# Specifying PLCA delay and overflow behavior

# **Specifying PLCA delay and overflow behavior**

Presenter: Wojciech Koczwaro, Rockwell Automation

# PLCA with big delay line (large number of nodes) - **PROBLEM**

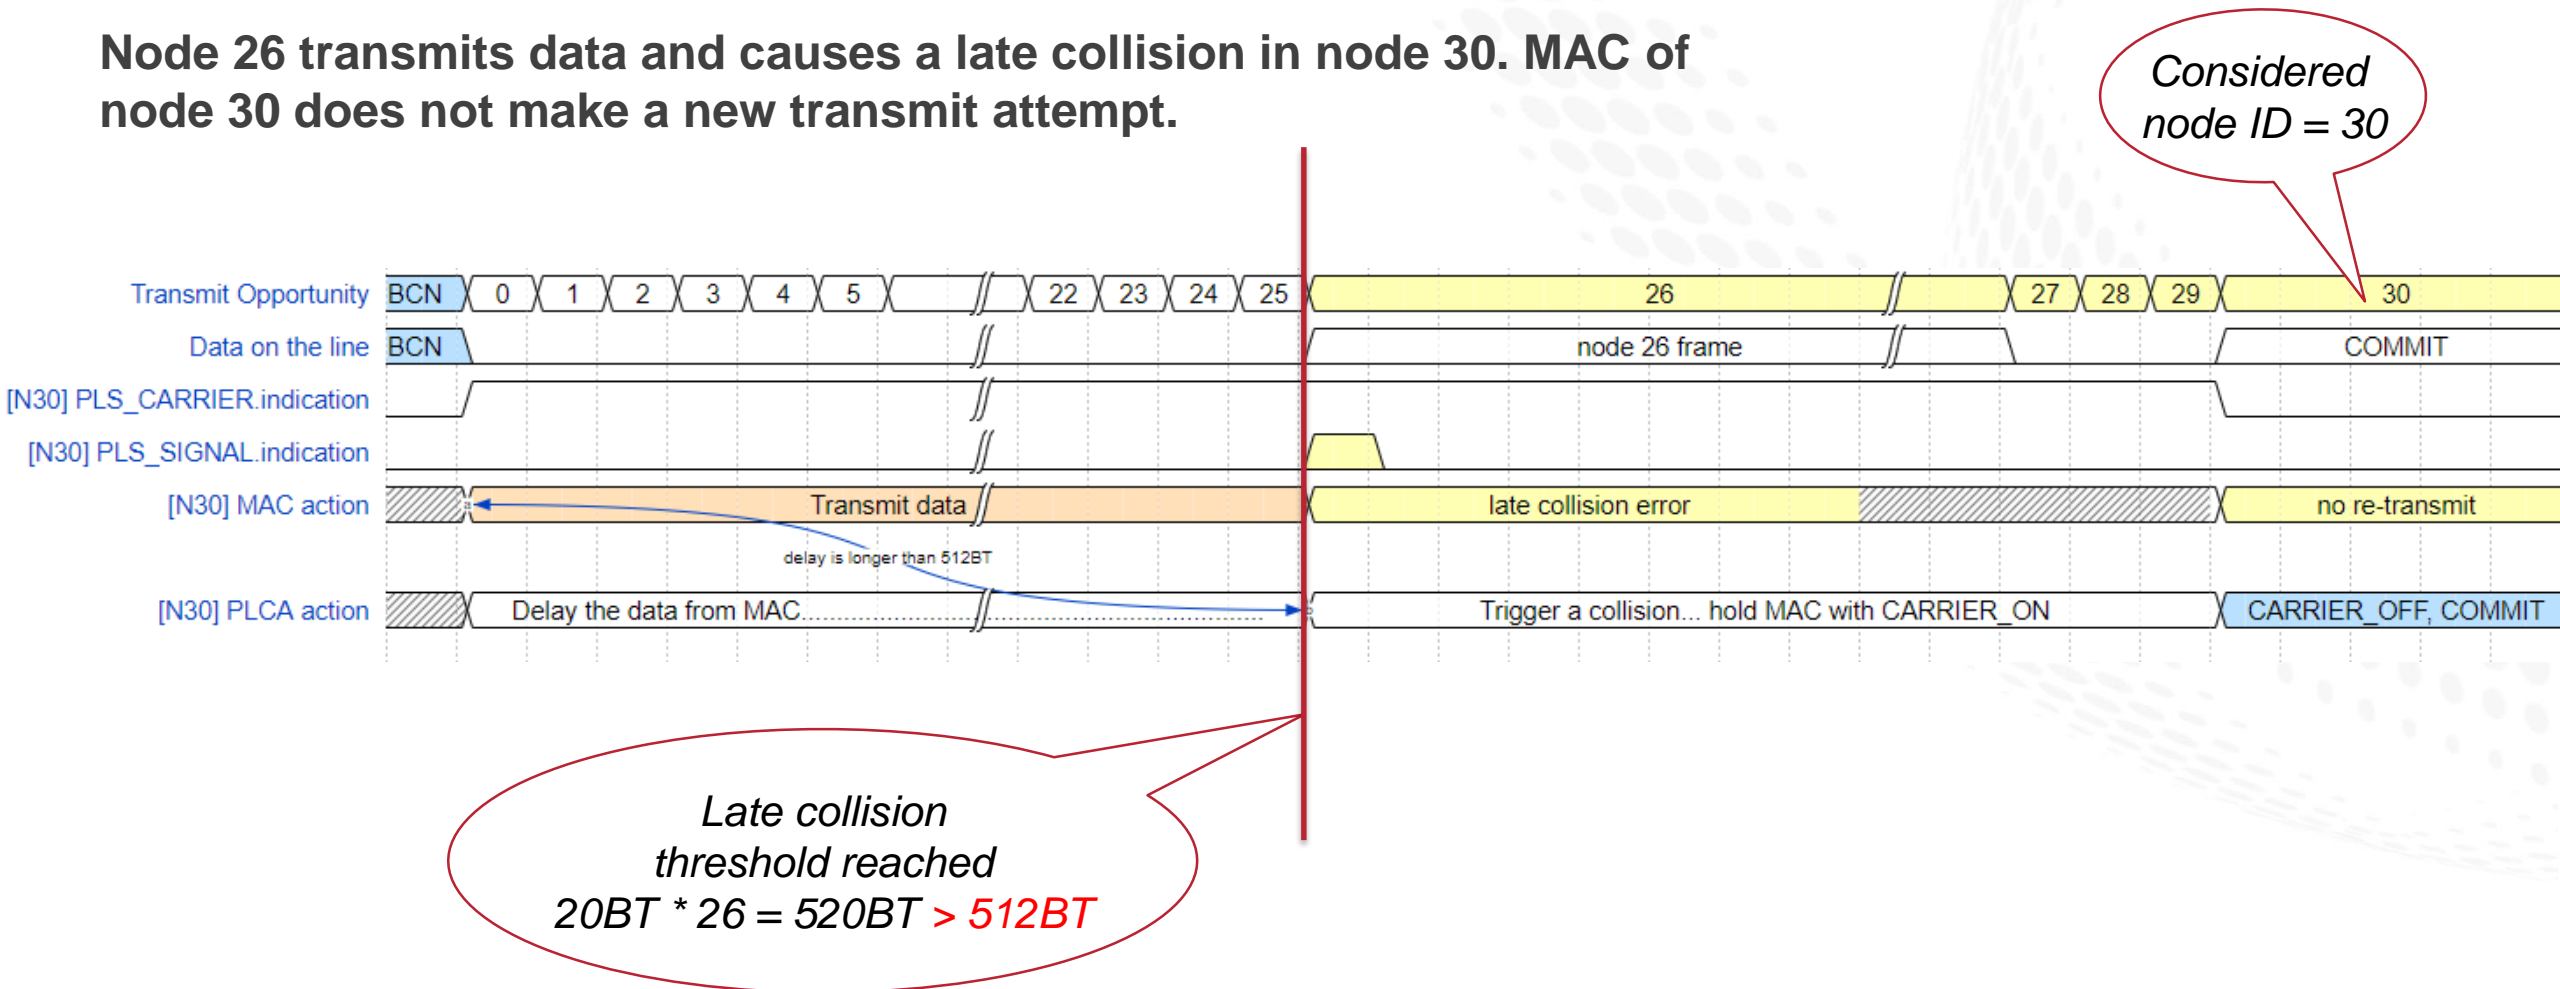
Due to excessive delay, late collision threshold ( $\geq 512\text{BT}$ ) is reached in MAC.

Node 26 transmits data and causes a late collision in node 30. MAC of node 30 does not make a new transmit attempt.

# PLCA with big delay line (to\_timer = 60BT) – PROBLEM

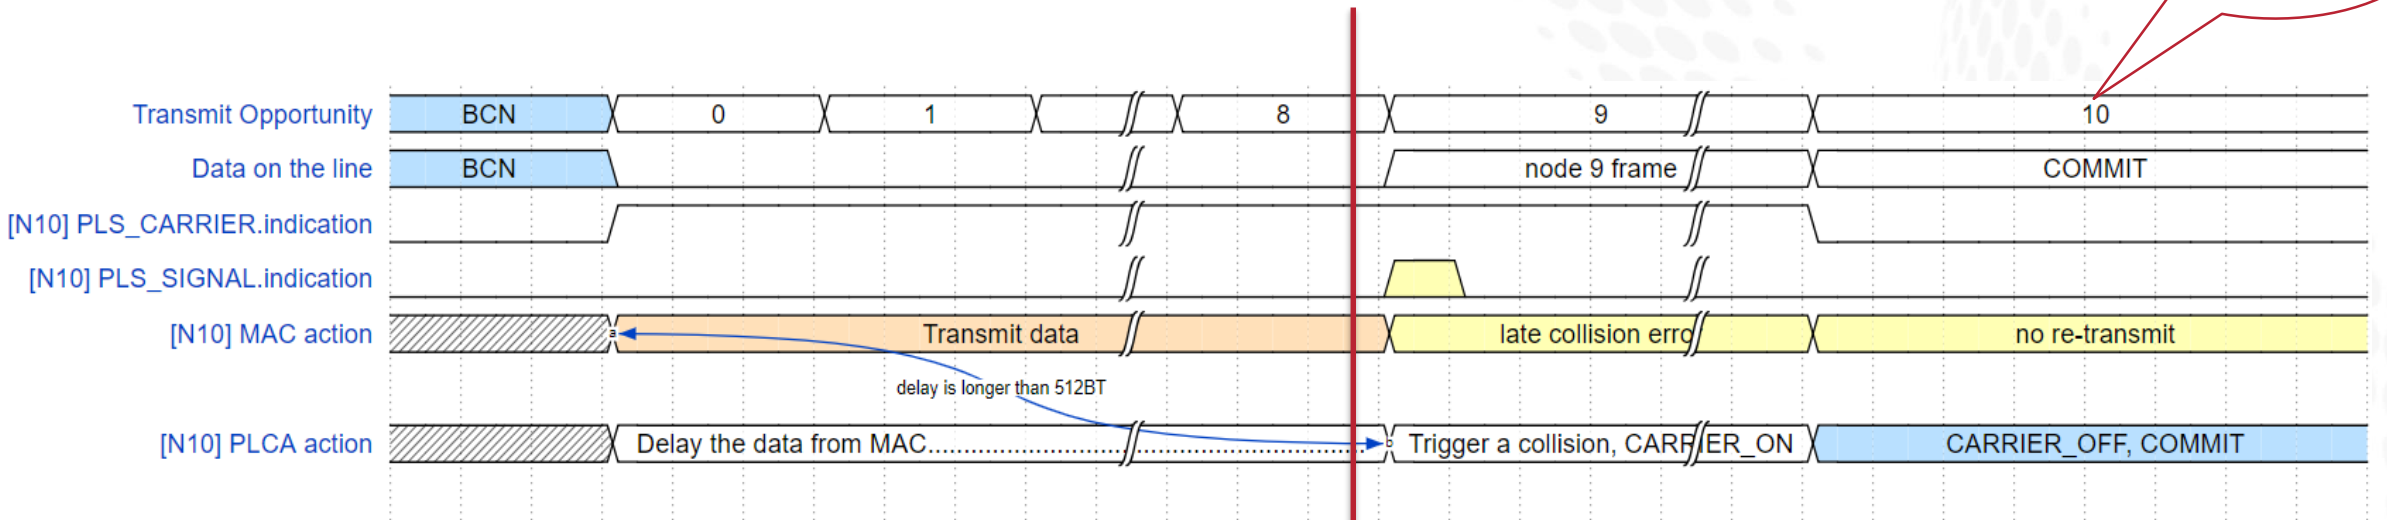
Node 9 transmits data and causes a late collision in node 10. MAC of node 10 does not make a new transmit attempt.

Late collision problem for 60-bit TO timer. Node 9 transmits and causes late collision in Node 10.

Late collision threshold reached  
 $60\text{BT} * 9 = 540\text{BT} > 512\text{BT}$

- i-198:

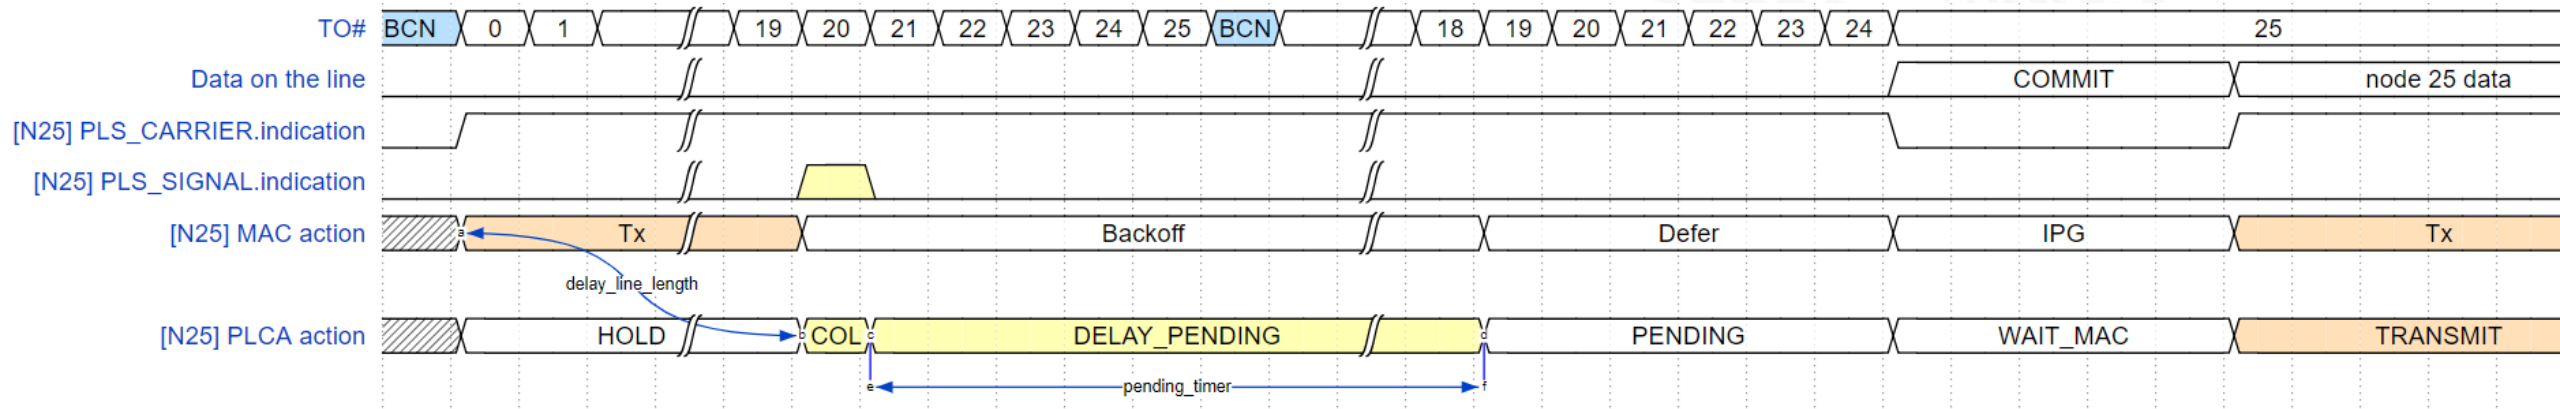
*Variable delay line in PLCA RS can overrun slotTime, resulting in late collisions.*

The variable delay line length shall be limited to assure there are no late collisions.

When the maximum delay line length is reached, trigger a collision to the MAC.

Use pending\_timer to cover MAC back-off time, then continue with the deferred transmission method.

Figure 148-4—PLCA DATA state diagram

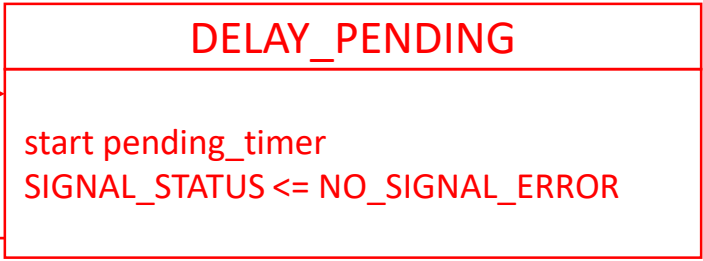
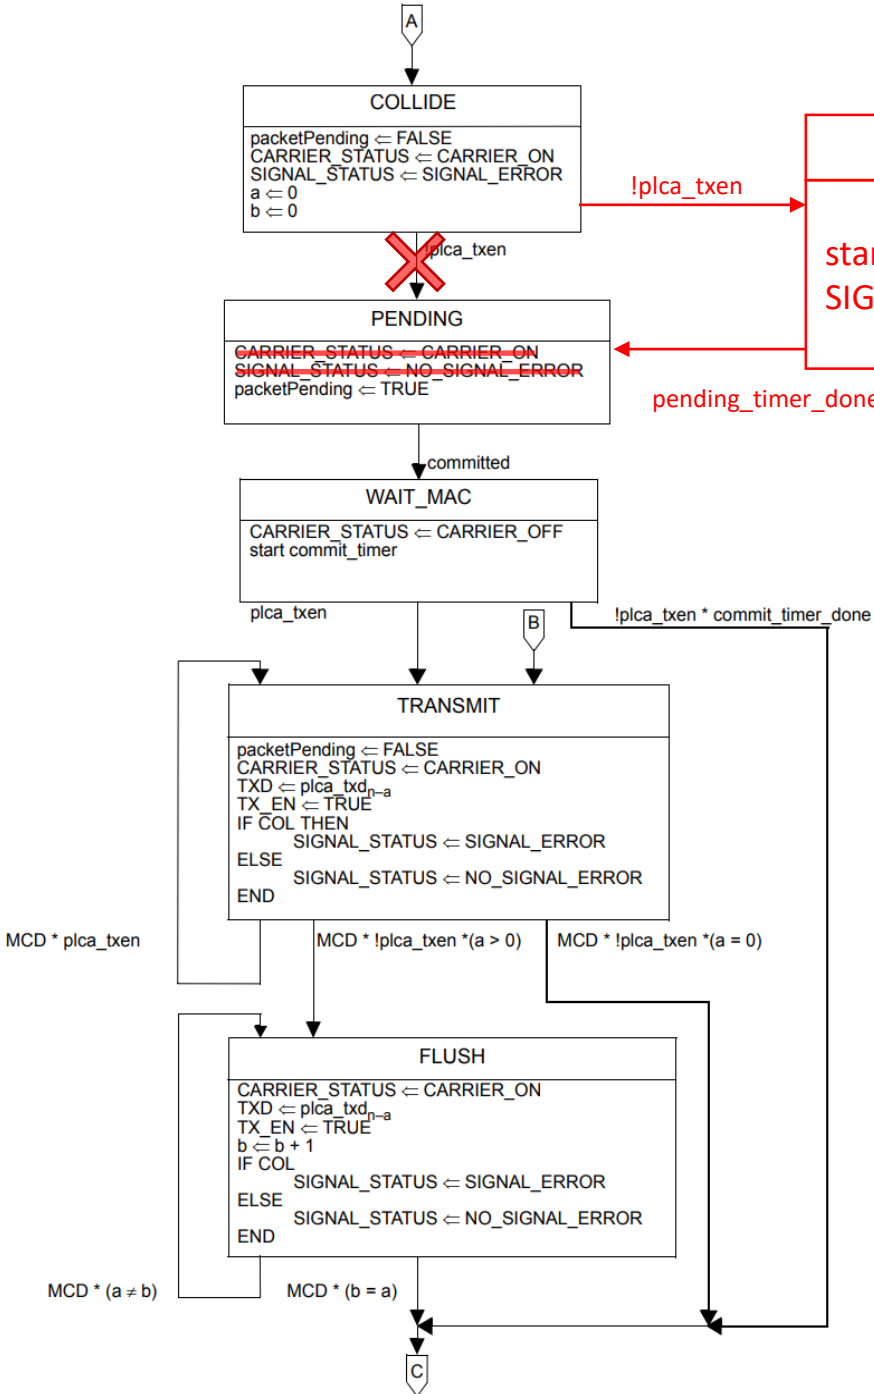
In Figure 148-4, in the transition from the HOLD state to the A connector, change the condition to:

“  
 rcv\_timer\_done +  
 receiving +  
 a ≥ delay\_line\_length  
 “

In Figure 148-4 do the following:

1. remove the transition from the COLLIDE to the PENDING STATE and its associated condition
2. In Figure 148-4, add a new state DELAY\_PENDING between COLLIDE and PENDING states.
3. Add a transition between COLLIDE and DELAY\_PENDING states with the following condition: “!plca\_txen”
4. Add a transition between DELAY\_PENDING and PENDING states with the following condition: “pending\_timer\_done”
5. Add the following text inside the DELAY\_PENDING state box:  
 “start pending\_timer  
 SIGNAL\_STATUS  $\Leftarrow$  NO\_SIGNAL\_ERROR”
6. From the PENDING state delete “CARRIER\_STATUS  $\Leftarrow$  CARRIER\_ON” and “SIGNAL\_STATUS  $\Leftarrow$  NO\_SIGNAL\_ERROR”
